FIRST REVIEW
WC³ Project #: 217-525-135

Subject: Ron Yehuda SFD – Plan Review Comments

Project Name: Ron Yehuda SFD

Location(s): Lot 65 Summit Powder Mountain, Eden, UT

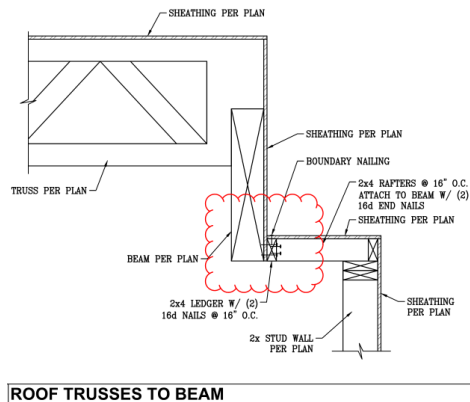
- S1. Fasteners, including nuts and washers in contact with preservative treated wood shall be protected according to IBC 2304.10.5.1. Please verify and address as required.
- S2. The jogs of the building disrupt the continuity of the top plate chords. Please verify that the chord or sub chord extend far enough into the adjacent diaphragm to develop the axial force through shear transfer. This may require additional blocking and straps. Diaphragm sheathing to resist direct tension or compression forces is not permitted. Please see ASCE 7-10 1.4, 12.1.3, 12.10 and 12.11.2.2.

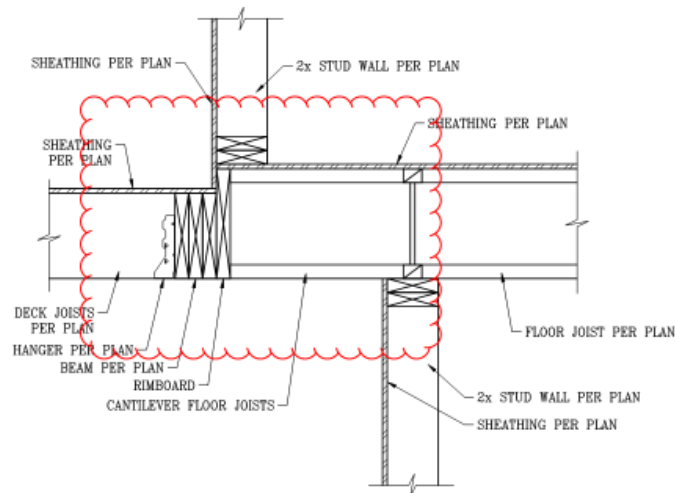
- S5. Sheet SD.1:
- A. Detail 4 shows an offset diaphragm condition. ASCE 7 12.11.2.2.3 does not permit the use of nails subject to withdrawal nor shall wood ledgers or framing be used in cross grain bending or cross grain tension. Please consider providing strapping for the members in shear.

- B. Detail 11 shows an offset diaphragm condition. ASCE 7 12.11.2.2.3 does not permit the use of nails subject to withdrawal nor shall wood ledgers or framing be used in cross grain bending or cross grain tension. Please consider providing strapping for the members in shear.
